Access Compliance Report

Public Rights-of-Way

(Curb Ramps)

Intersection ID: 2458	Main Street: HIGHLAND_CREEK_PY	Cross Street: MCCHESENEY_DR	Location: S
ADA ID: 32AA7CCA06B7	Ramp Type: Perp	Initial Pass/Fail: Fail	Overall Compliance: No
		Severity Score: 72.5

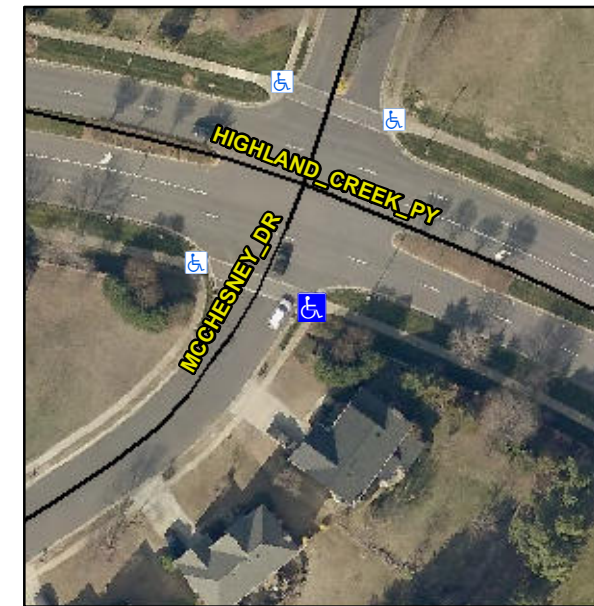
R304.5.1, R304.2.2, R304.5.3

Compliance	Description	Data	Compliance	Description	Data
N/A	Ramp Length (in)	112.0	No	Ramp Slope (%)	9.2
No	Ramp Width (in)	30.0	No	Ramp XSlope (%)	7.6
N/A	Flare Type LT	N/A	N/A	Flare Type RT	N/A
N/A	Flare Slope LT (%)	N/A	N/A	Flare Slope RT (%)	N/A
N/A	Flare Traversable LT?	N/A	N/A	Flare Traversable RT?	N/A
N/A	Landing Length (in)	N/A	N/A	DWS Provided?	N/A
N/A	Landing Width (in)	N/A	N/A	DWS Contrast?	N/A
N/A	Landing Slope (%)	N/A	N/A	DWS Length (in)	N/A
N/A	Landing X Slope (%)	N/A	N/A	DWS Full Width?	N/A
N/A	Landing Curb? (Y/N)	N/A	N/A	DWS Offset (in)	N/A
N/A	Shared Landing?	N/A			
N/A	Gutter Ponding?	N/A	N/A	Gutter Slope (%)	N/A
N/A	Gutter Lip Ht (in)	N/A	N/A	Gutter X Slope (%)	N/A
N/A	Painted X Walk1?	Yes	N/A	Painted X Walk2?	N/A
	X Walk 1 Direction	To NW		X Walk 2 Direction	N/A
N/A	X Walk 1 Width (in)	93.0	N/A	X Walk 2 Width (in)	N/A
	X Walk 1 Slope (%)	3.8		X Walk 2 Slope (%)	N/A
	X Walk 1 X Slope (%)	4.2		X Walk 2 X Slope (%)	N/A

Remove & Replace Entire Ramp.
